Planning Commission Meeting Agenda
Hartland Township Hall
Thursday, January 12, 2023
7:00 PM

HARTLAND TOWNSHIP PLANNING COMMISSION **DRAFT** MEETING MINUTES

SITE PLAN REVIEW – Applicable Site Standards

HARTLAND COMMERCE CENTER
PHASE III & IV CONSTRUCTION PLANS
COVER SHEET

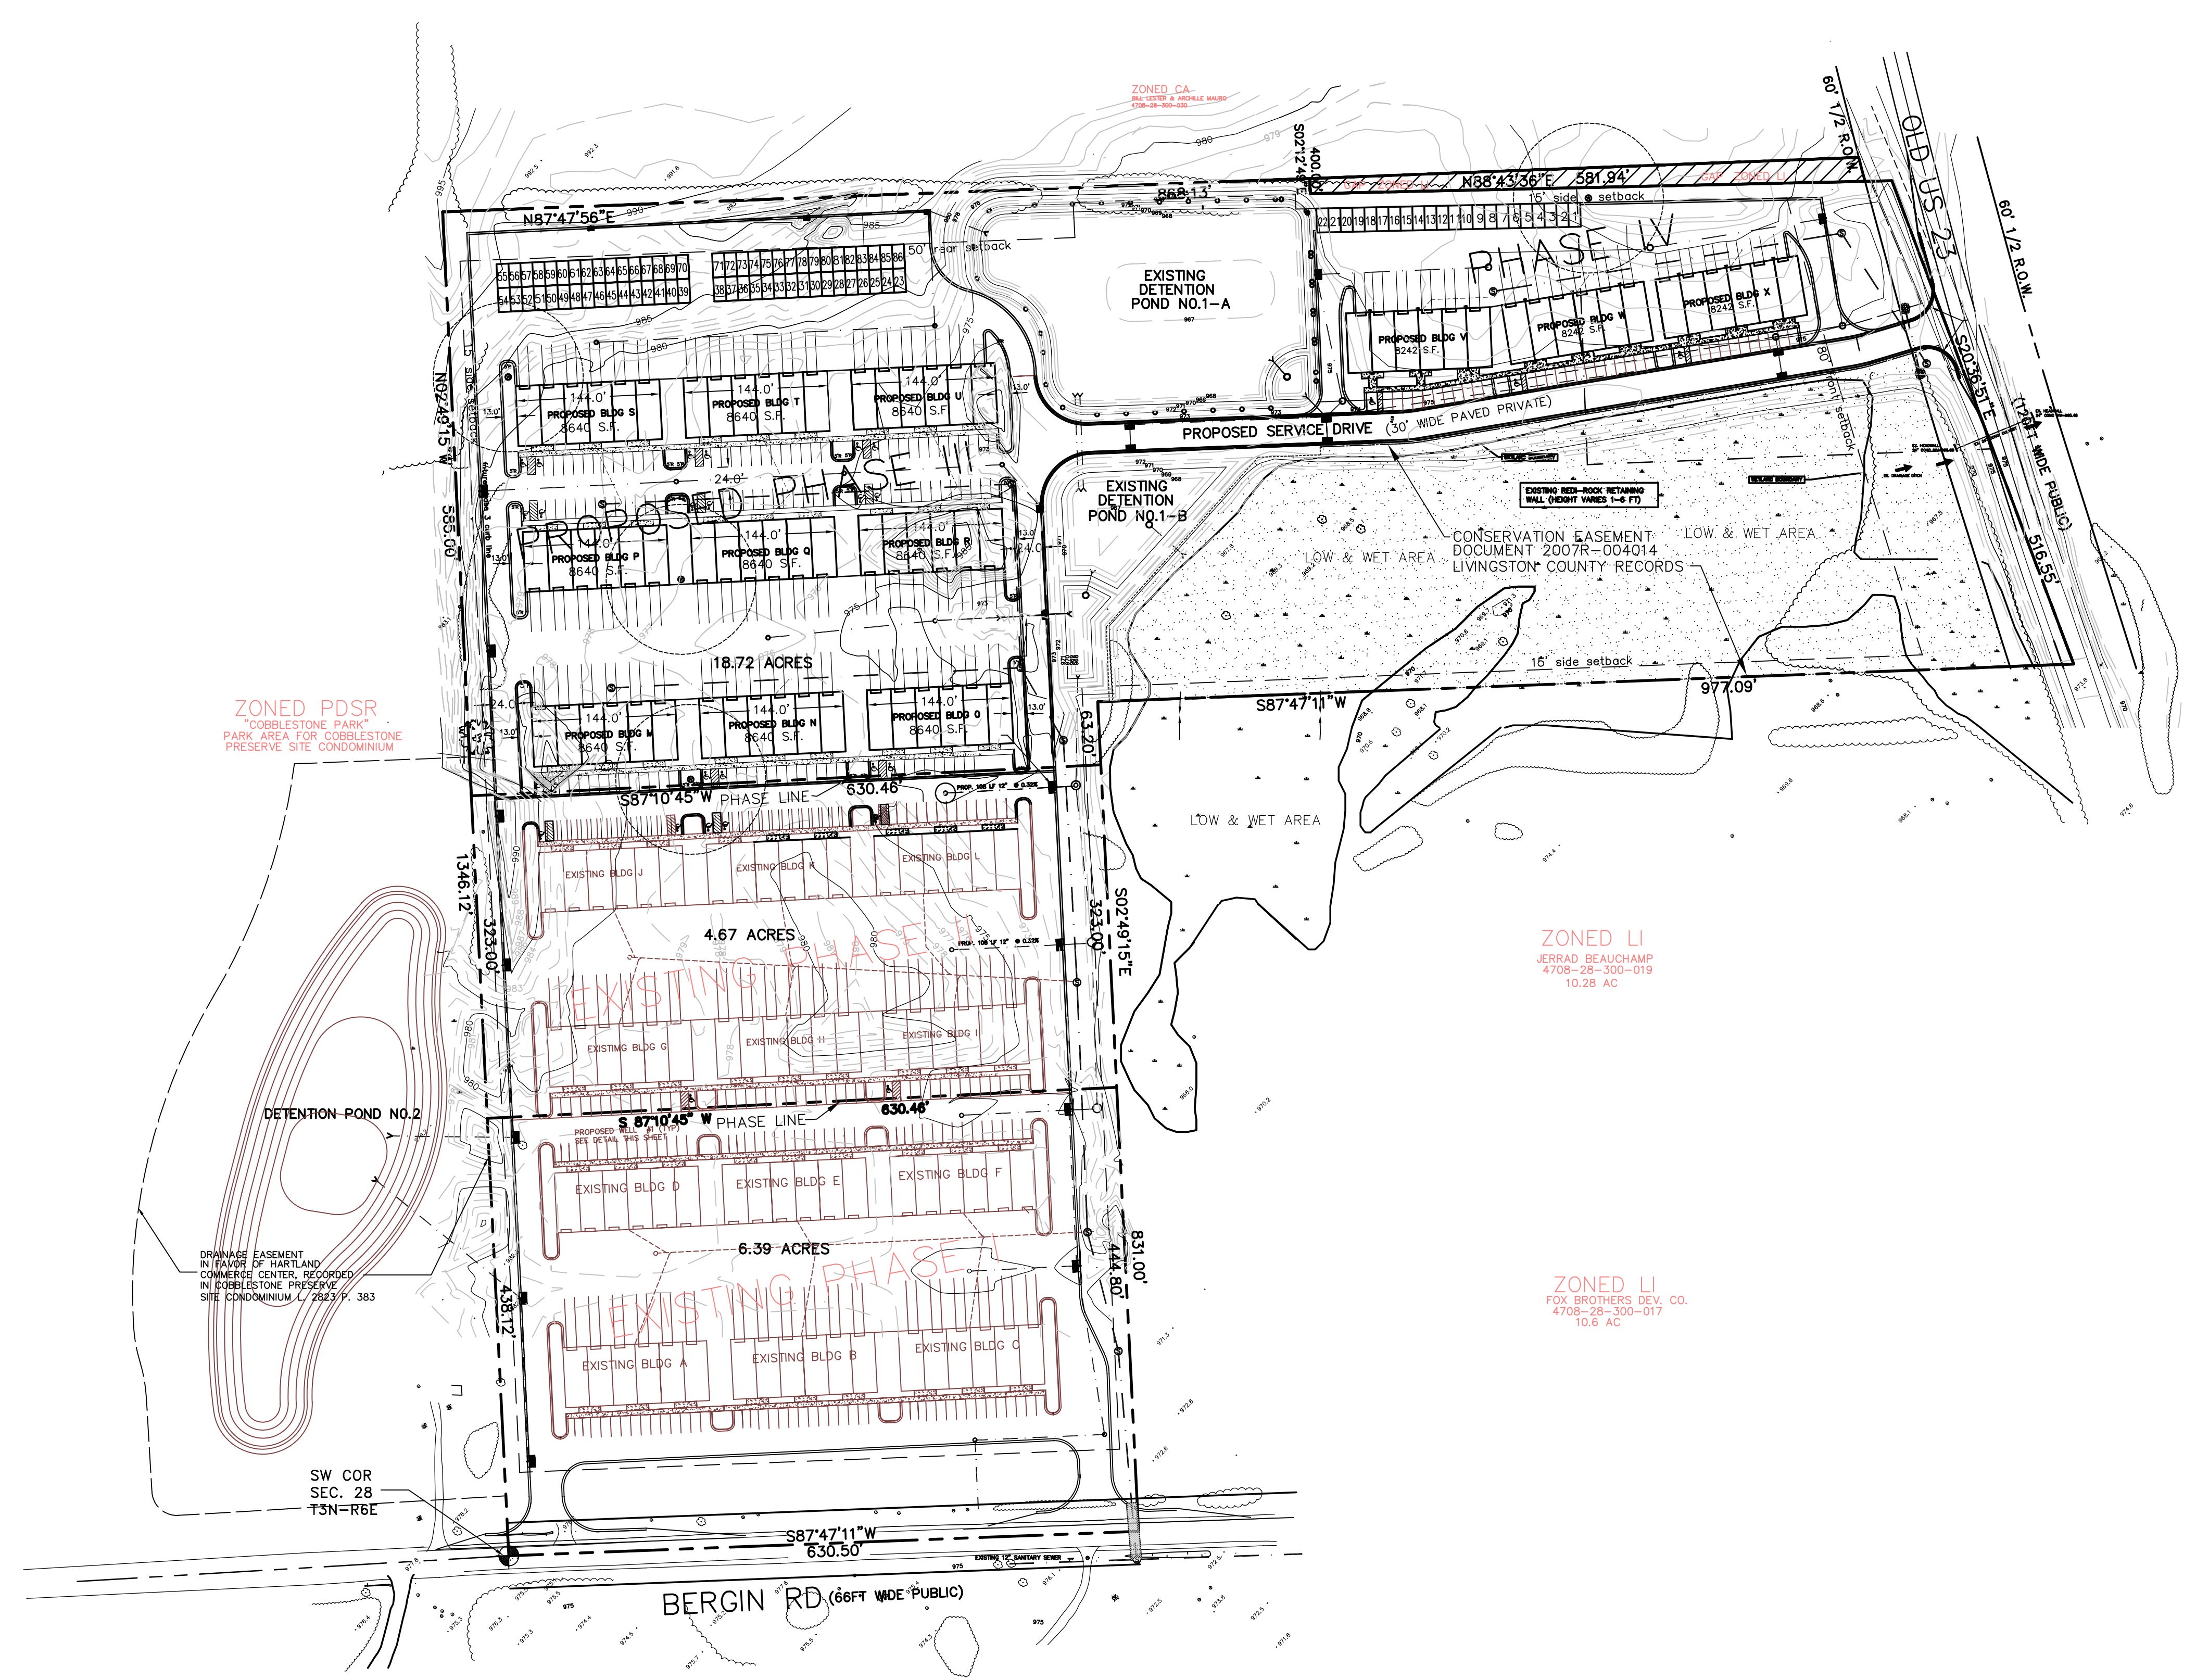
As an informational note, the plans (Sheet 3.4) state that the square footage of each building in Phase IV is 8,242 square feet. Per the applicant this represents the square footage of the interior space. The outer building dimensions (building footprint) are stated as 60 feet by 144 feet, which equals 8,640 square feet. The building dimensions scale correctly (60 feet by 144 feet). The stated building square footage (footprint) should be corrected on the Construction Plan set. The total square footage of the three (3) buildings is 25,920 square feet (3 x 8,640 SF).

- Meets Requirement? – **TBD** - See staff's recommendations below.
- Comment – **Summary of comments for Phase IV:** Based on Sheet 3.4, approximately 7 planting areas are shown (Bldg. V, W, and X), each 5-foot wide. Due to the roof overhang and the width of the planting beds (5 feet wide), the proposed ornamental trees (flowering crabapple-species not defined) will not thrive in those locations and could be placed elsewhere. The conceptual landscape plan shows a total of four (4) ornamental trees. Two (2) larger planting beds are shown in front of Building V and may provide enough space for 2-4 additional ornamental trees. Shrubs, groundcover, perennials are required in each foundation planting bed to cover approximately 80% of the ground to avoid weeds. Revisions to be shown on the Construction Plan set if the Planning Commission is in favor of the suggested revisions. Applicant is seeking comments from the Planning Commission.
